**CD-061-10, U.S. Army Corps of Engineers, Pismo Beach**

**RE: Vista Del Mar Army Corp SeaWall Proposal  
(CD-061-10) Pismo Beach Shoreline Protection**

**REVISED STAFF RECOMMENDATION****ON CONSISTENCY DETERMINATION**

EXHIBIT 9  
CD-061-10  
Florin St. - Existing Vertical Wall

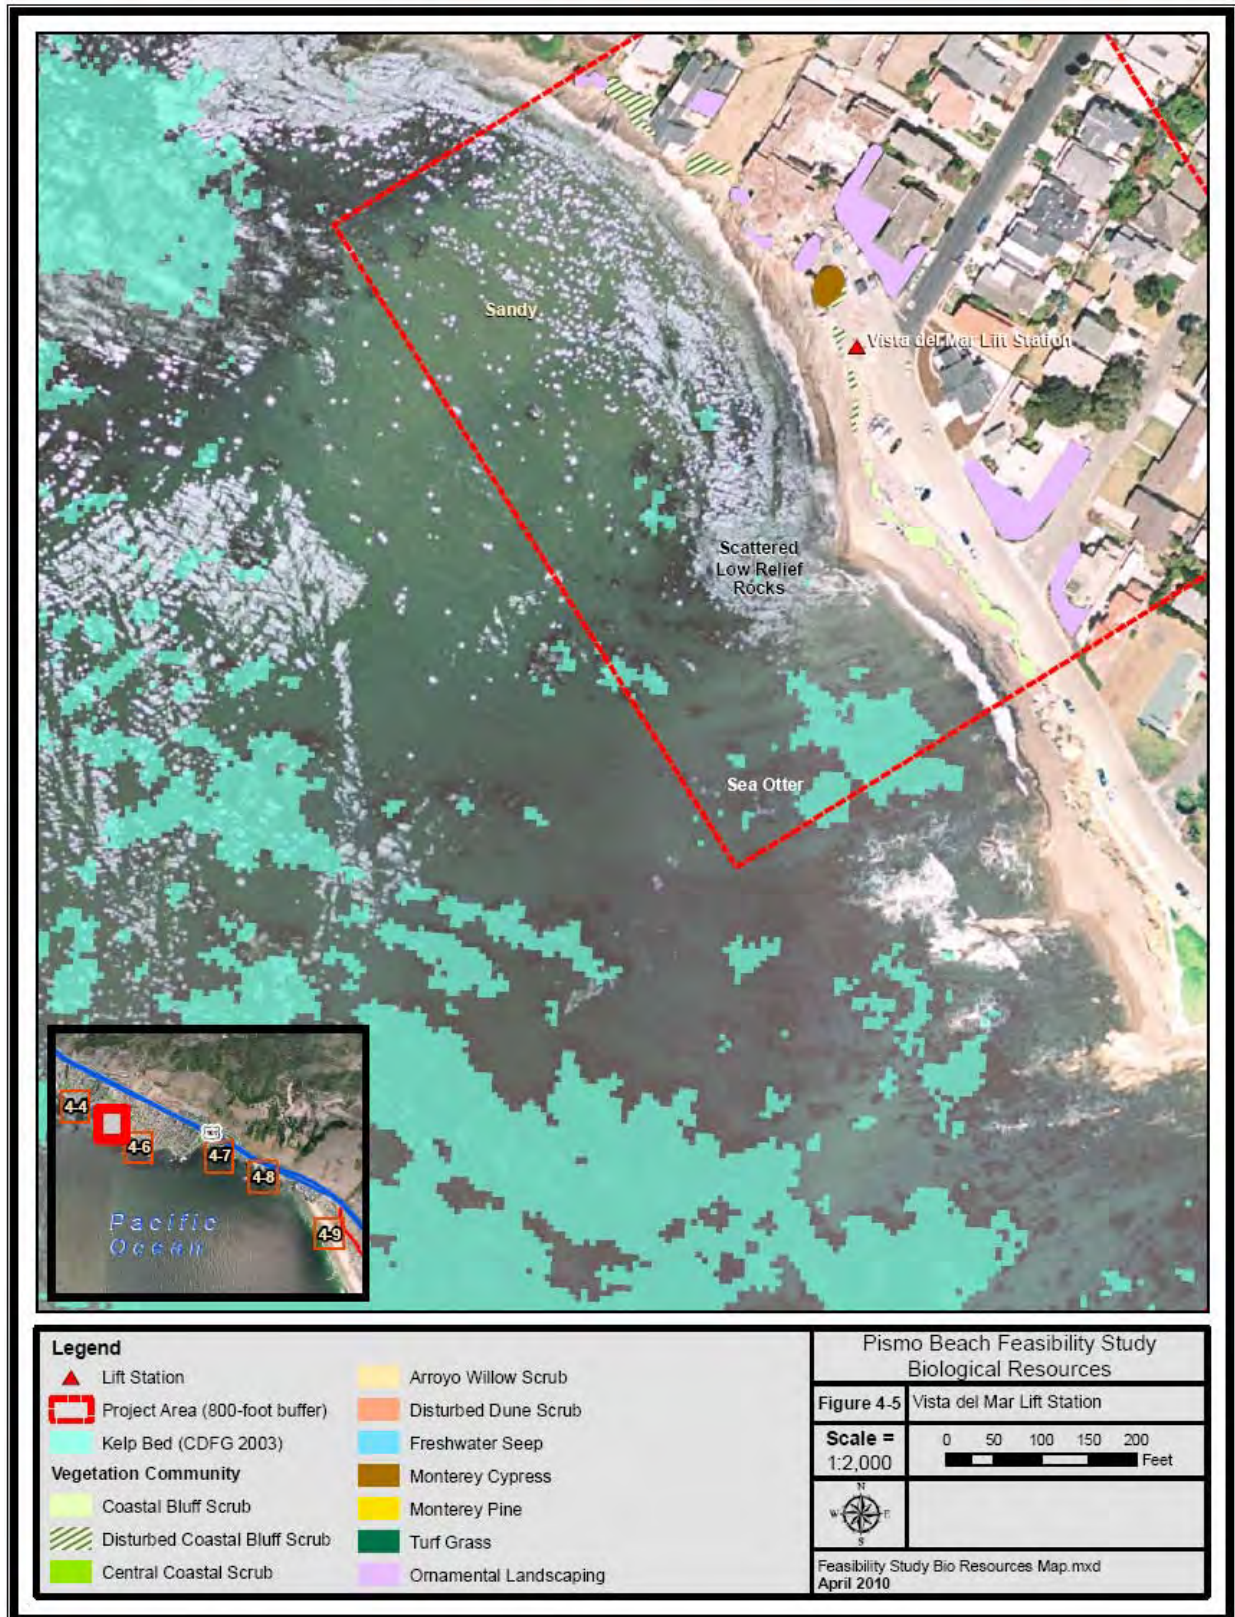
**5. Design & Aesthetics.** The example included in the EA of a curved wall providing an "aesthetic" treatment on a wall at Florin St. in Pismo Beach is not a good example of what we would consider an adequate aesthetic treatment at this date. We would direct you to several more recently designed and built examples which provide much greater aesthetic sensitivity. The first example is the wall the City of Santa Cruz recently built at Pleasure Point, which is above the rock formations for the most part, and aesthetically designed, and which can be seen in Santa Cruz shoreline photos at this website:

5. *Design & Aesthetics. The example included in the EA of a curved wall providing an "aesthetic" treatment on a wall at Florin St. in Pismo Beach is not a good example of what we would consider an adequate aesthetic treatment at this date. We would direct you to more recently designed and built examples which provide much greater aesthetic sensitivity. The first example is the wall the City of Santa Cruz recently built at Pleasure Point, which is above rock formations for the most part, and aesthetically designed, and which can be seen in Santa Cruz shoreline photos . . . . The second example is the Pebble Beach Co. seawall at Cypress Point in Monterey County . . . . As we noted/requested previously: Please provide a visual simulation of the proposed seawall facing that includes a natural combination of colors that provide a mottled appearance, which is more consistent with the appearance of a natural bluff face than a single uniform color. If a specific contractor has been chosen to do the facing work, please provide photographs of representative samples of this contractor's work. Please also be aware that the only walls that have been approved by the Commission for the past 5 or 10 years have included a visual treatment. Even some revetments have had a visual treatment. It is unlikely that Option 2 – an untreated vertical wall – would be considered currently to be an acceptable alternative for any location on the coast.*

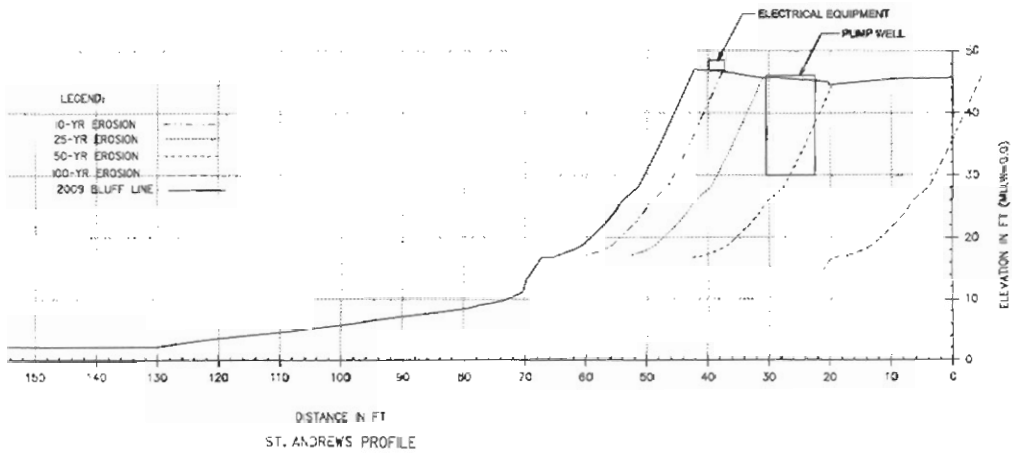
These statements would appear to be mutually exclusive. Please clarify. Also, if walls were permitted by the County rather than the City, prior to incorporation, then the County should also be contacted to determine whether it has any permitting and authorization records.
